Docket Item #8
BAR CASE# 2004-0144

BAR Meeting
July 28, 2004

ISSUE: Addition
APPLICANT: Vanna So
LOCATION: 1204 Princess Street
ZONE: RB/Residential

Figure 1 North elevation

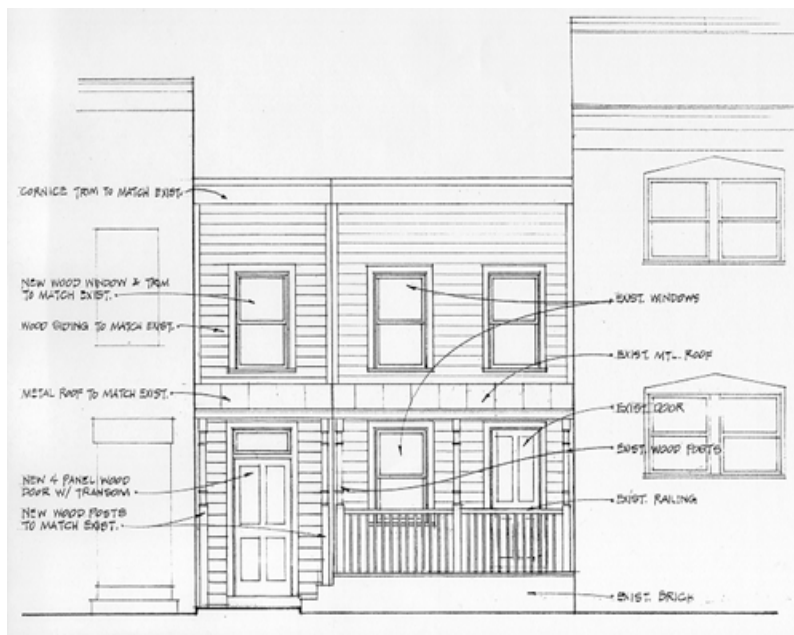
The front (north) elevation of the addition will be approximately 7.5' wide, filling in the unbuilt area to the east of the house. It will be set back from the front wall of the existing house by 15.5 feet. Like the existing house, it will have a 5' deep single story porch at the front. The porch will be at grade and will have turned wood posts and a standing seam metal shed roof to match the existing porch. There will be a four panel door with full light transom on the first story and a one-over-one window above in the second story. The cornice trim on the addition will match that on the existing house.
